## MEMORANDUM

To: Planning Board  
From: Lauren A. Wasilauski, Open Space & Stewardship Director  
Date: February 7, 2024  
Re: PB-08-23: HMH Carrier Clinic, Inc.  
Block 2001 Lot 2 and block 1001 lot 14.02 (252 Route 601)  
Preliminary & Final Site Plan with Bulk Variances and Design Waivers

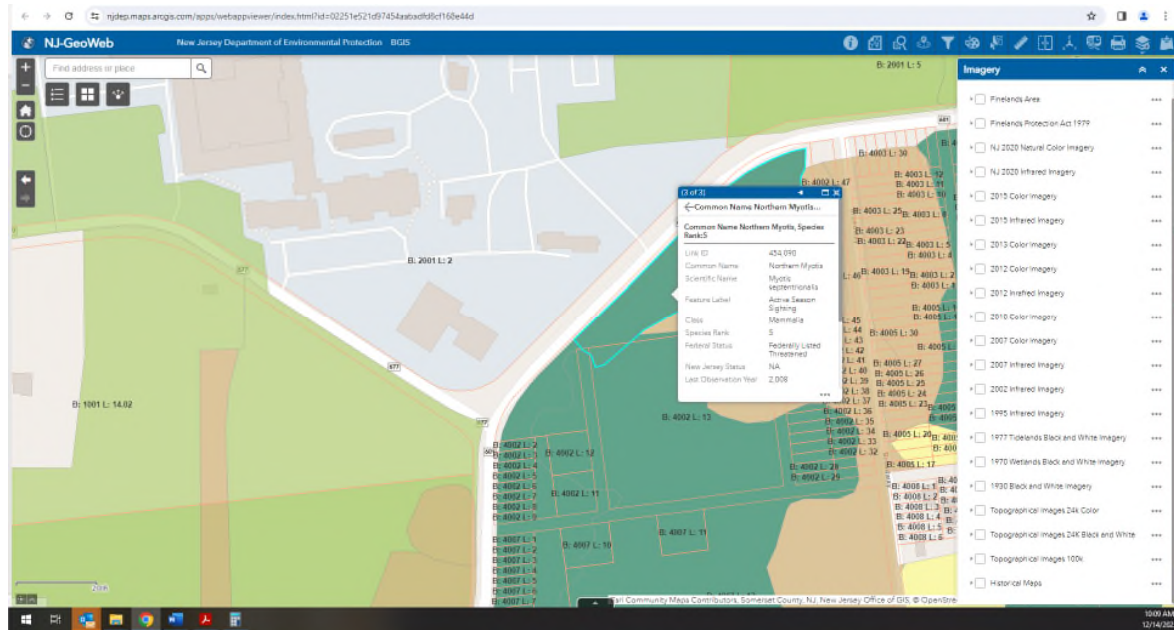
1. The Applicant’s proposal for a building addition on the west end of the site is in an area indicated by the NJDEP Landscape Project as breeding habitat for the American Kestrel, a State threatened species (screen grab below).

2. Township Code sections 16-5.2(e) & (g) and 16-6.4(e) require a conservation easement or conservation deed restriction on any threatened or endangered species habitat.
3. The Applicant’s EIS states that the “developed portion of the Carrier Clinic is not mapped as suitable habitat.” (Section VI.E Wildlife). The Applicant should reconcile this statement with the map above in their testimony.

4. A conservation deed restriction may be impractical on this area given the existing and proposed development, but this office can't make a final determination without further details.
5. The Applicant should consider installing kestrel nesting boxes nearby.
  - a. The American Kestrel Partnership has tips on their website such as installing a box with the opening facing southeast, and not installing boxes near busy roadways: <https://kestrel.peregrinefund.org/nest-monitoring>
